SERVICE DEPARTMENT BULLETIN

BULLETIN #91129

GENERAL CLASSIFICATION: Control Deck Repair
SPECIFIC SUBJECT: NES-CPU PCB (PART NO. 22667) 06 VERSION MODIFICATION

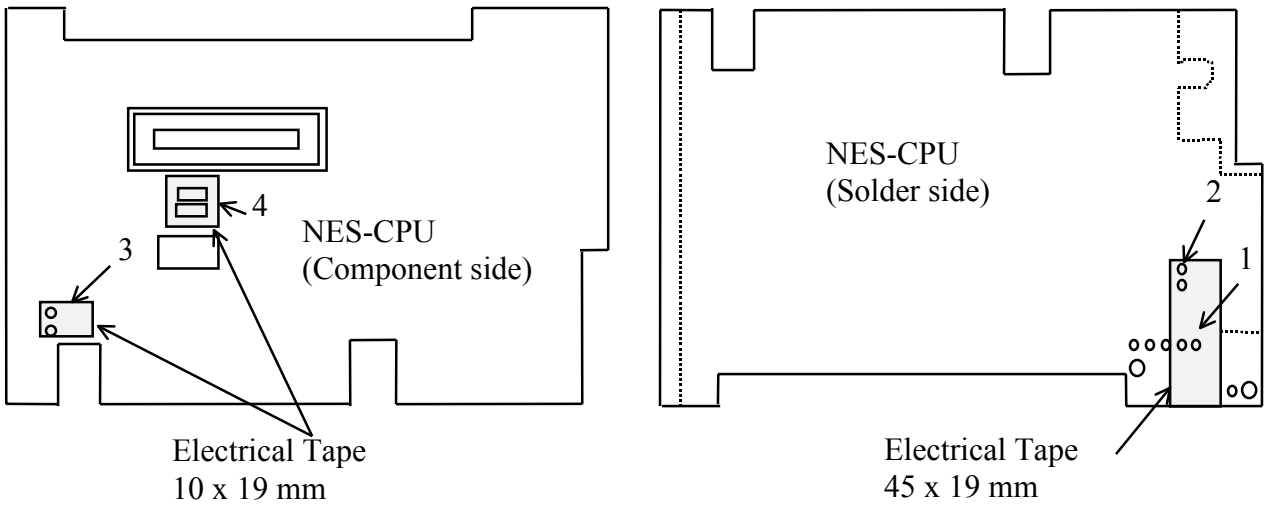
There is a possibility that circuit traces of the NES-CPU PCB 06 version will touch the upper or lower shield and cause a short circuit problem. To prevent this possibility, electrical tape must be applied to three locations on the PCB (refer to the figures below). For this application, the electrical tape should be rated UL-94 V-0.

Locations involving the problem:

1. Between the signal side trace of C33 and upper shield case.
2. Between the two through holes beside DA3, DA4, and upper shield case.
3. Between the four holes beside R3, R4, and lower shield case.
4. Between R9 and lower shield case.

Repair Action
